### **RESPONSE to Q2.5.3.4b**

# TECHNICAL NOTE

<b>DATE:</b>	09 June 2021	<b>CONFIDENTIALITY:</b>	Restricted
<b>SUBJECT:</b>	Alternative highway and drainage options for Roxton Road link (north)		
<b>PROJECT:</b>	70061368 – Dove House Farm, Wyboston	<b>AUTHOR:</b>	Anthony Groom / Joe Leslie
<b>CHECKED:</b>	Livio Martelli	<b>APPROVED:</b>	Livio Martelli

<b>Project:</b>	<b>A428 Black Cat to Caxton Gibbet</b>				
<b>Title:</b>	<b>Roxton Road Link Alternative Design Proposal at Dove House Farm</b>				
<b>Doc ID:</b>	<b>HE551495-ACM-GEN-GEN_ZN1_SR_Z_ZZ-TN-CH-0001</b>				
<b>Date:</b>	<b>September 2020</b>	<b>Version:</b>	<b>P01</b>	<b>Status:</b>	<b>S2</b>

**Table 1 Areas of land acquisition**

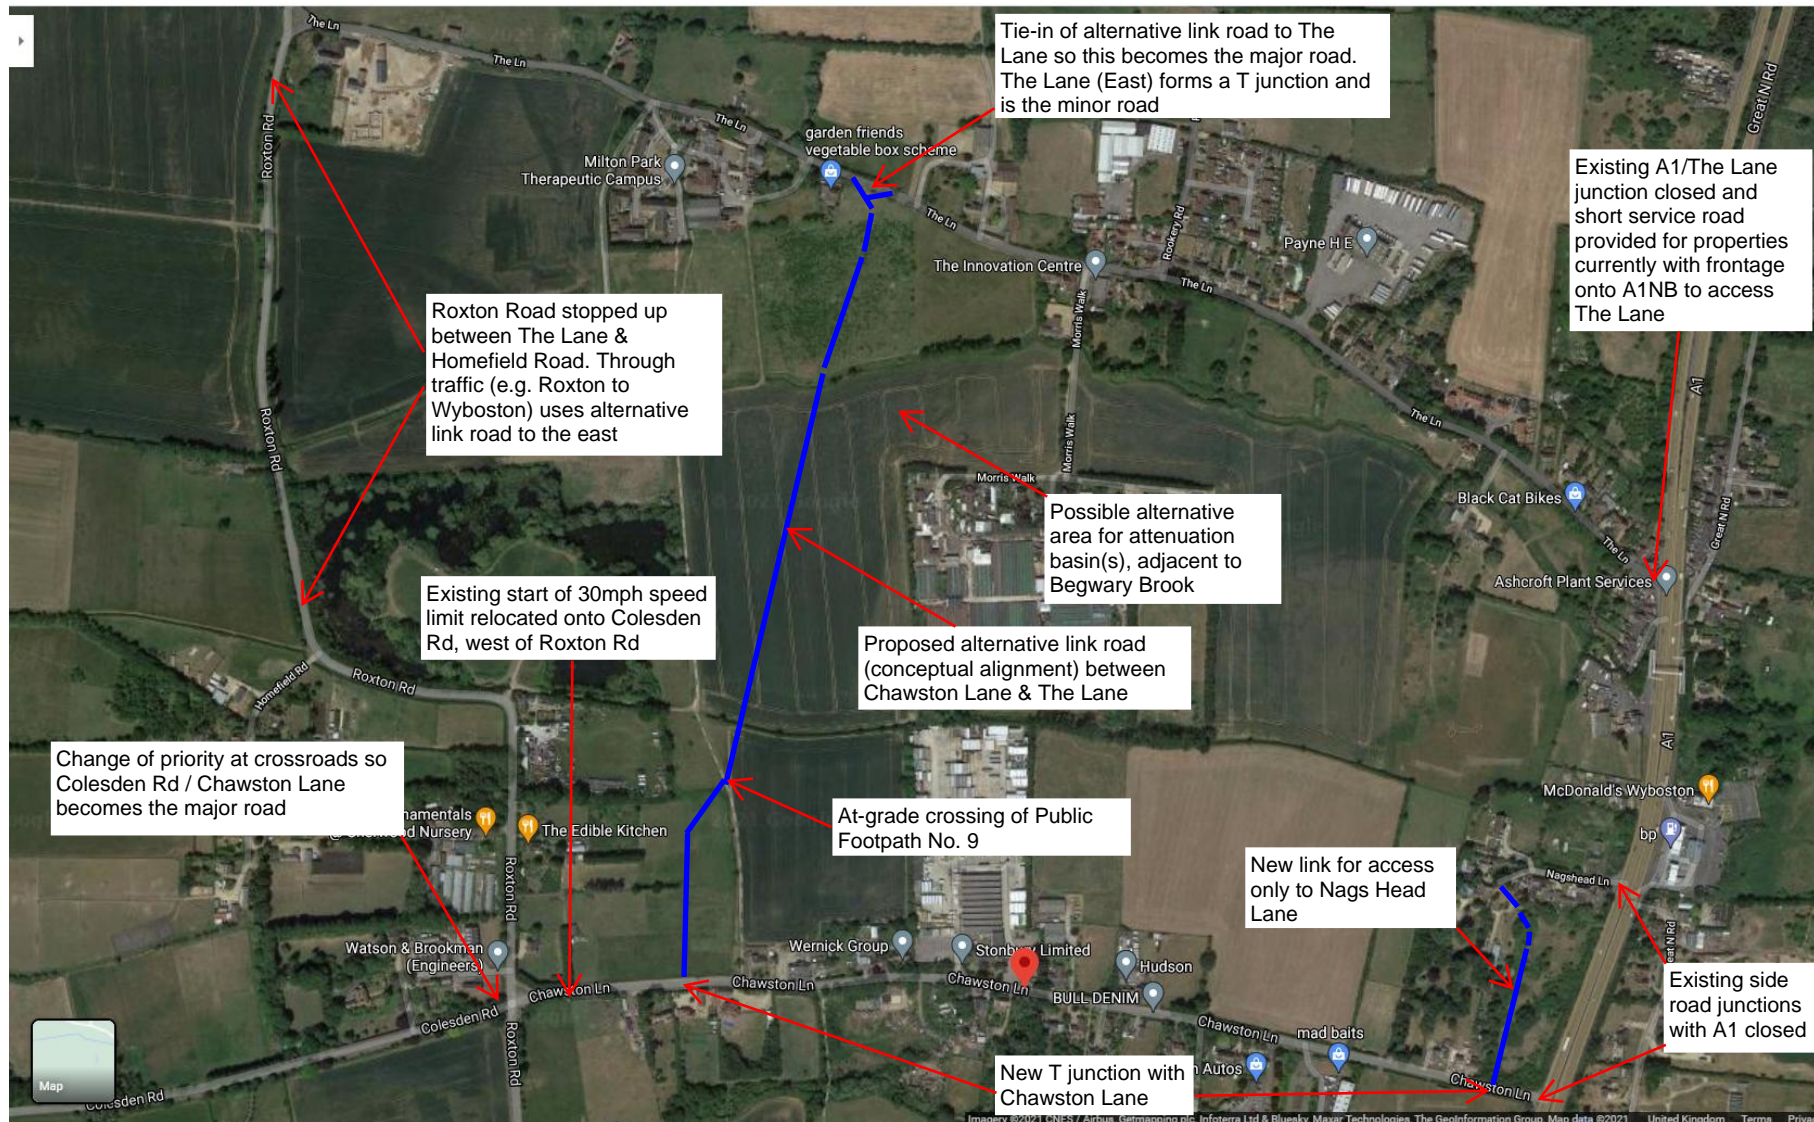
1.1.16 The total area values in Table 5 show that each case, with or without the landscape review, the scheme design requires less land than the WSP alternative.

1.1.17 The WSP design does require less land to be acquired from Dove House Farm, but requires land from another landowner in order to achieve this.

1.1.18 In summary, comparing the two designs;

- The two designs will both provide speed control at the double bend.
- MfS2 clause 8.3.8 and MfS1 clause 7.4.4 imply that the alternative design would not provide as much speed control as the scheme design, firstly because the first bend uses a larger radius and secondly the forward visibility around both bends is greater than required by standards. The impact of the shorter application of the tighter radius is probably marginal.

- The alternative design moves the road closer to existing residential properties.
- The alternative design requires the removal of at least 25m of existing hedge that provides a noise and visual screen to properties on Nags Head Lane.

- The alternative design does not reduce the area of land that Highways England would need to acquire permanently. It does reduce permanent land acquisition at Dove Farm, but requires permanent acquisition of land elsewhere to mitigate.

- i) Whilst the alternative design may require more land than the proposed layout, according to HE's calculations this would equate to 0.0386 hectares of additional land which is considered to be a modest amount in the overall context of the Scheme. Furthermore, due to the drainage design issues described on pages 3 & 4 of this note, subject to further design iteration there would appear to be an opportunity to reduce the land requirement of the alternative design such that the overall land requirement of each design could be broadly similar.

- ii) These comments are largely due to drafting issues when preparing the alternative design as it was only possible to use pdf versions of the Scheme drawing to generate the alternative design. They could be satisfactorily addressed through further design iteration and through the availability of drawings and topographical information in AutoCAD format.

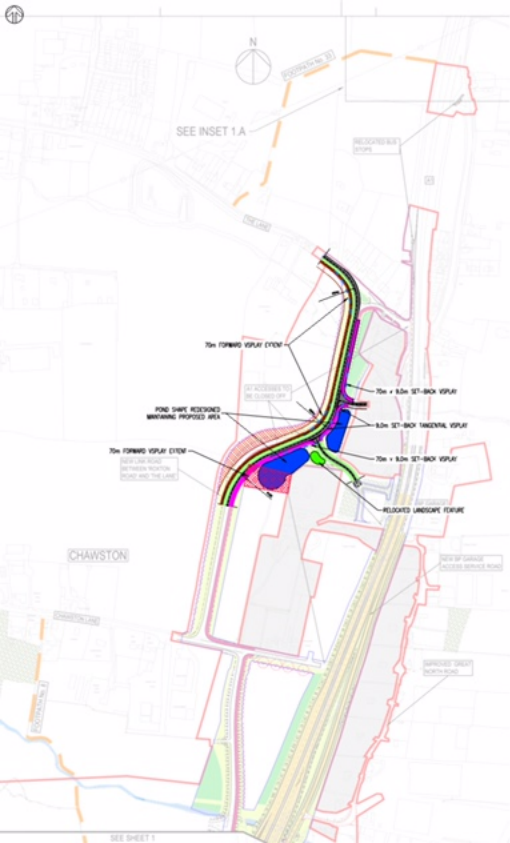
Considering the extent of the 70m forward visibility splay and the need for a widening on tight radii curves, a new alignment was sketched using radii of 54m and 100m (drawing reference 1368-WSP-00-XX-SK-CV-0001 P02). This value allows for more flexibility around the central section of the scheme without compromising forward visibility, swept path analysis or safety.

The proposed layout (drawing reference *1368-WSP-00-XX-SK-CV-0001 P02*) would save approx. 2300m<sup>2</sup> of land on the western side of the road, while increasing the land take on the eastern side by approx. 1960m<sup>2</sup>. The feasibility of the above is yet to be confirmed by a formal design stage.
